ARCHITECT'S SUPPLEMENTAL INSTRUCTIONS

PROJECT: Lee Lofts II. Building 2 Report No. Eleven (11)

Lee Lofts II, Building 2Historic Bldg Rehabilitation

Architect's Proj No. 21-3120

A1.3

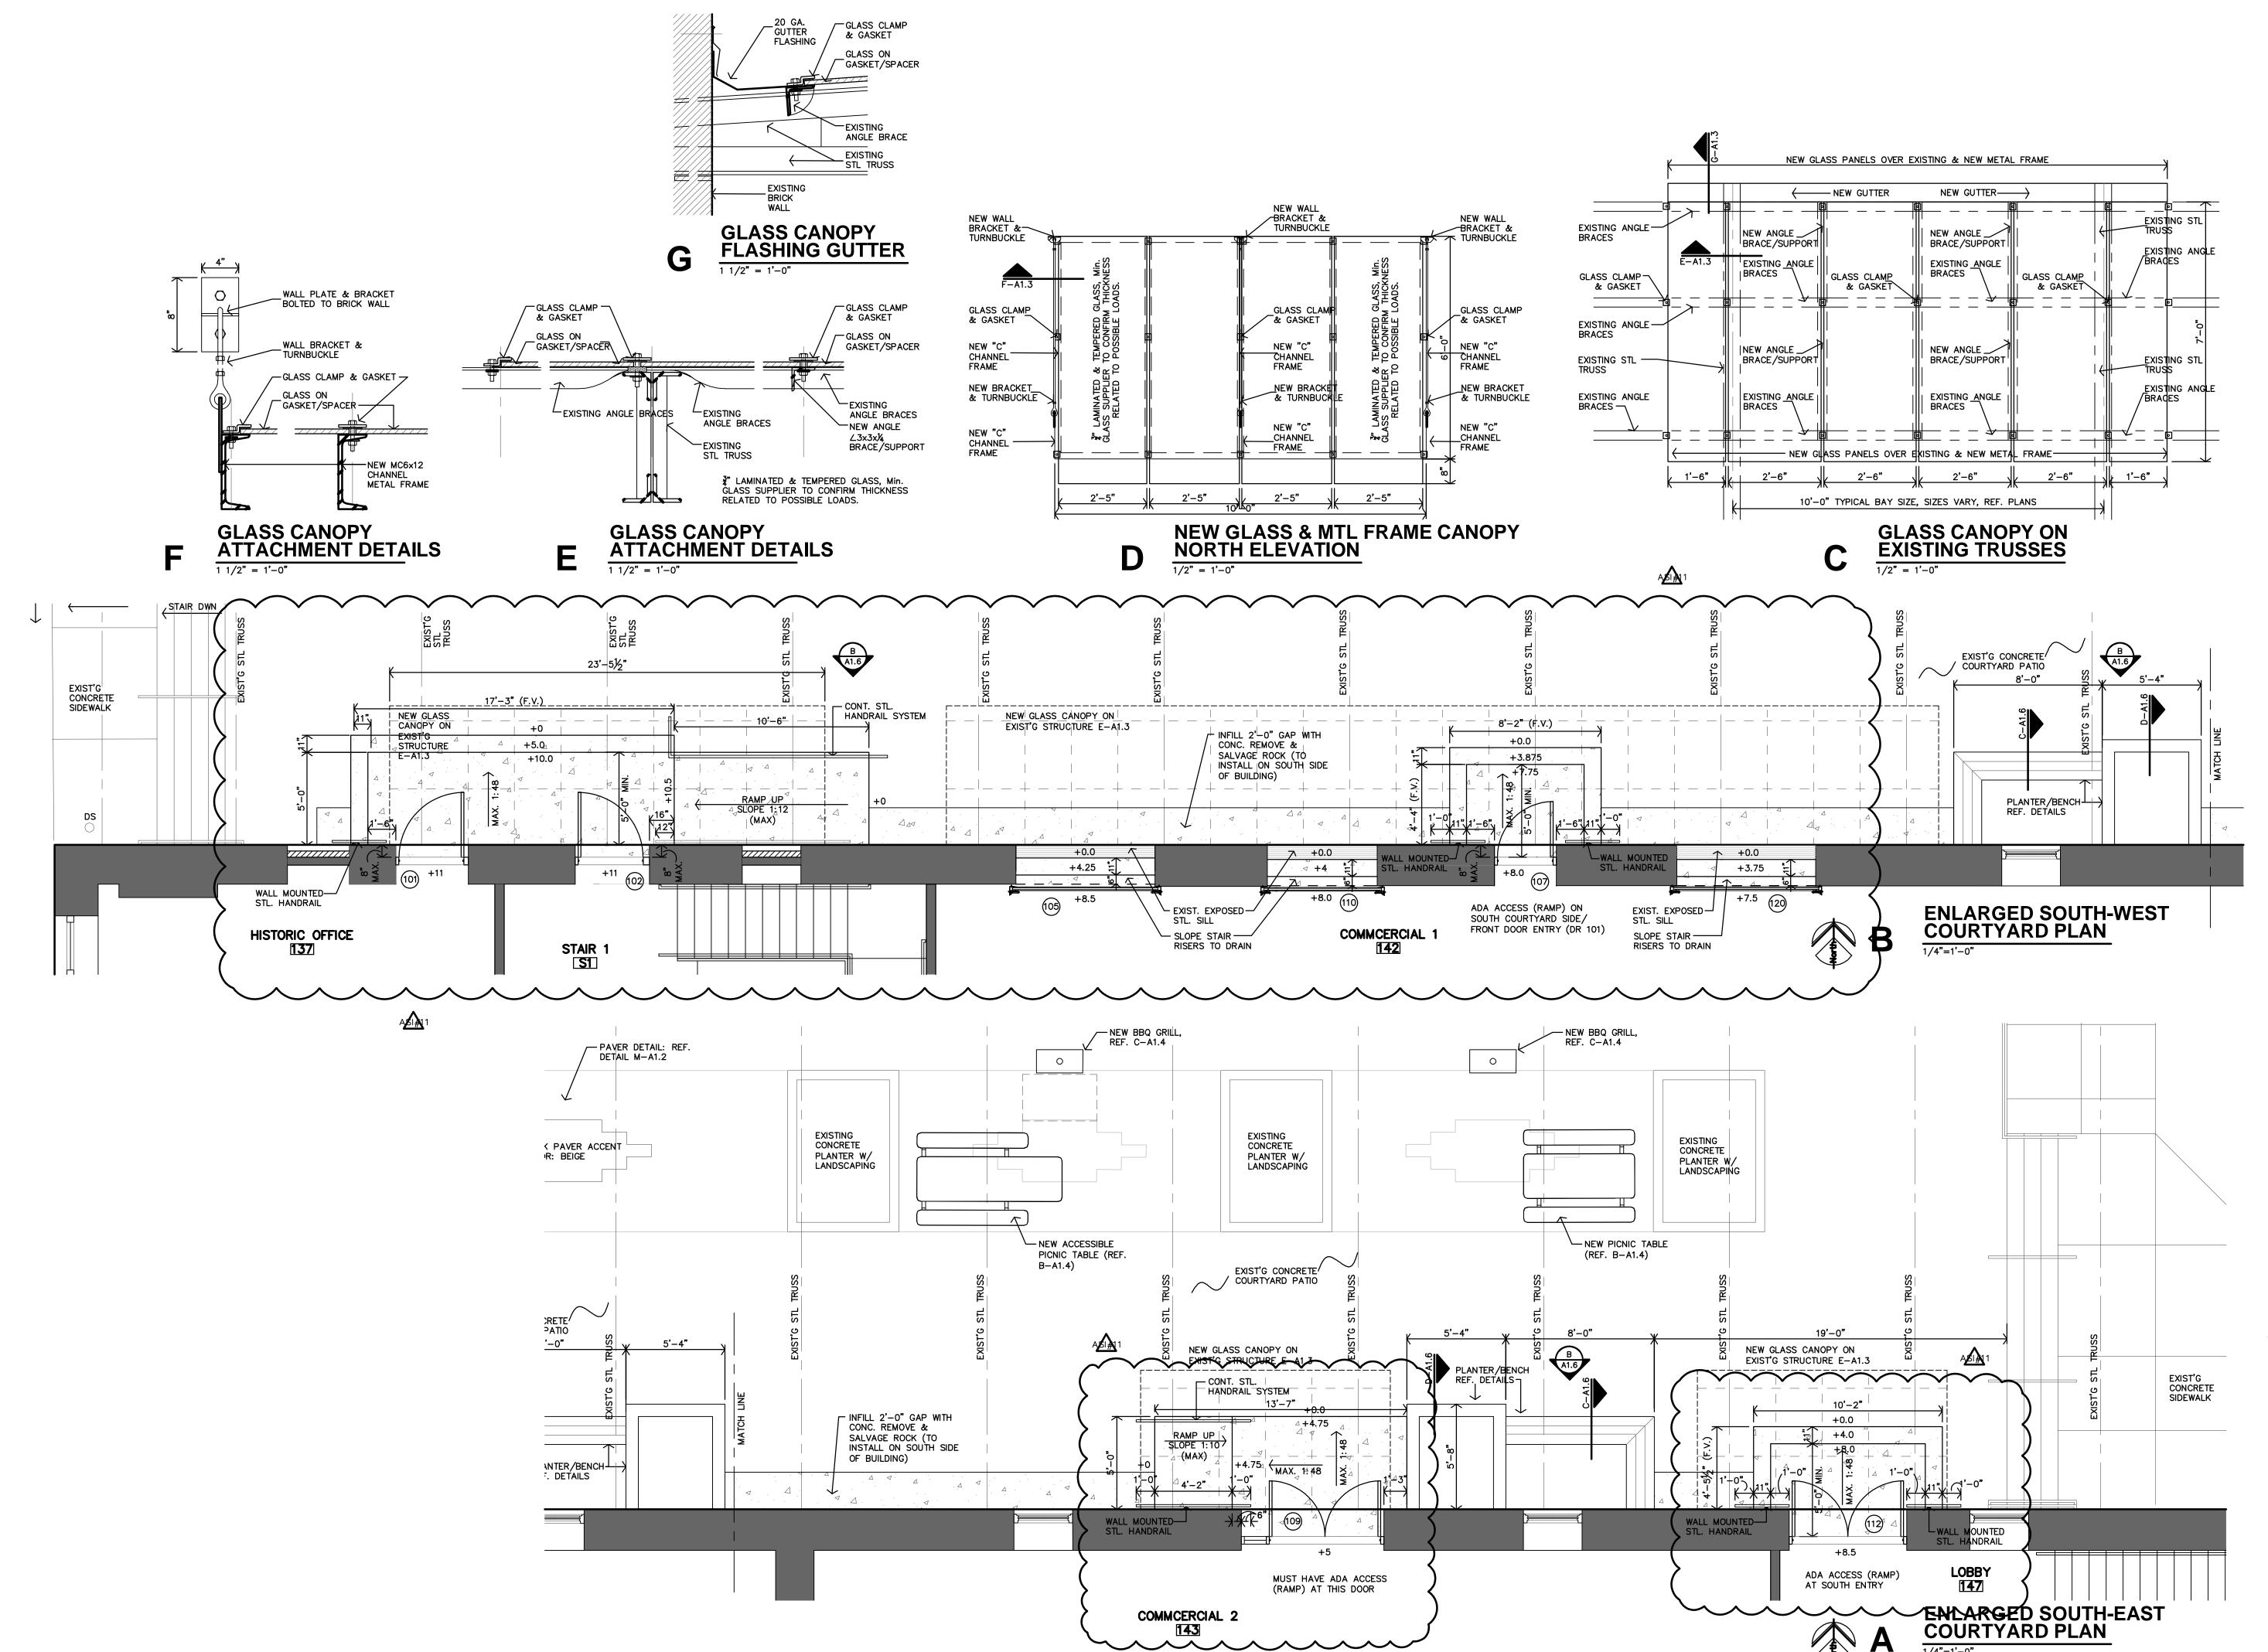
On the first floor, North Courtyard Façade - Because the light weight leveling concrete was poured higher in some place than anticipated in the drawings, we will need to add stairs and ramps at most door and entry locations to the North Courtyard.

- At Doors 101 & 102
 - a. Raised Planter and bench between Doors 102 & 105 has been eliminated to allow space for new ramp and stair.
 - b. Install new 2 riser stair system and 1:12 ramp with handrails as shown in the attached revised sheet A1.3.

- c. Glass Canopy above has been shift to the East by 1 truss, to cover more entry space.
- 2. At Doors 105, 110 and 120 (Overhead Doors)
 - a. Extend raised floor out 6" past the interior building face. Install 1 new riser on top of the existing steel sill below. Retain small area of steel lintel at exterior of opening to meet grade. Reference the attached revised Sheet A1.3.

- 3. At Door 107
 - a. Install new 2 riser stair system, with wall-mounted handrails on both sides of the door.
- 4. At Door 109
 - a. Install 1:10 ramp with handrails and 1 riser stair.

- 5. At Door 112
 - a. Install new 2 riser stair system, with wall-mounted handrails on both sides of the door.

Note: Attached is the original sketch from the contractor's superintendent, which depicts the elevation differences at each door. Elevations should be field verified again after final gypcrete floor is poured and final engineering flooring is installed. Elevations may need to be adjusted at each stair/ramp location. Notify Architect of any major changes.
